BULLETIN 30071

MINECRUISER BULLETIN

Date: 20/12/2013

BULLETIN MineCruiser

Drive Shaft hoop

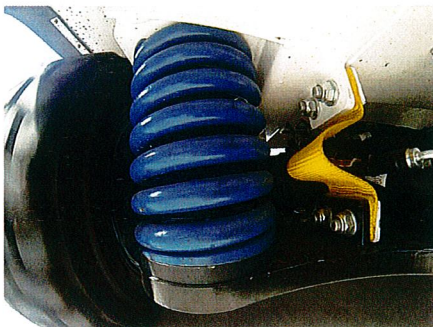
A MineCruiser has become unstable as a result of the rear drive shaft falling to the ground while the machine was in transit. A drive shaft hoop (7-045339-700) to retain a failed drive shaft is now available to suit Mk7 MineCruisers. This simple device will contain the rotational energy in the drive shaft and prevent a failed shaft contacting the ground where the failure occurs on a dynamic vehicle.
